# Rosedale: Bevian Rd Concept Application (MP05-0199) Response to Public Submissions and Referrals to Government Agencies

Marsim has received a summary of submissions from the Department of Planning arising from the public exhibition of the Bevian Concept Application and copies of comments from various government agencies as follows:

# **ATTACHMENT 1**

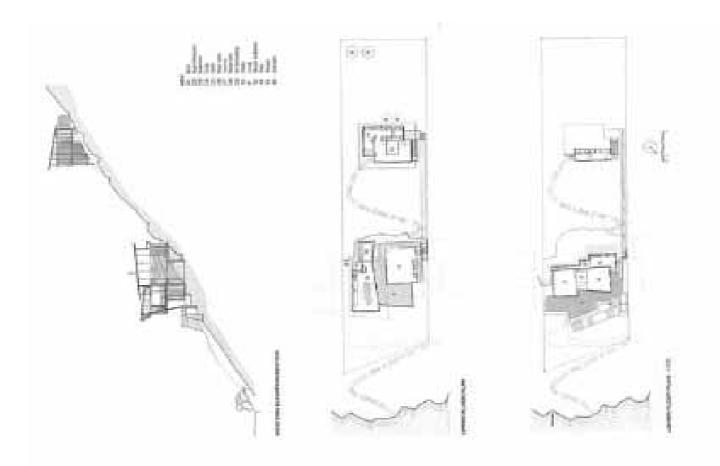
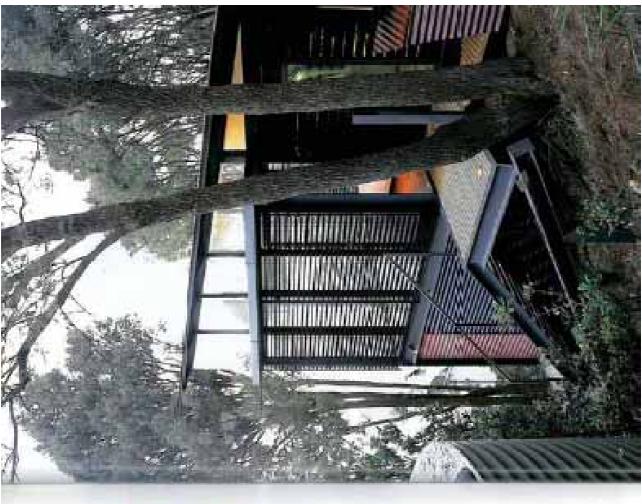
• Raises concern about the creation of small lots on steep land at the southern end of the site.

Concern about the subdivision of some of the steep land zoned 1c Rural (SW corner of the site) and suggests that it should not be disturbed - assertion that there is no policy basis to support the development of land with slopes exceeding 25%. Small lots on Steep Land

In areas of greater slopes lots are deeper to enable the construction techniques above which minimise earthworks. For example (Attachment 1) James Robertson House is built on a 50% slope in Pittwater, Sydney.
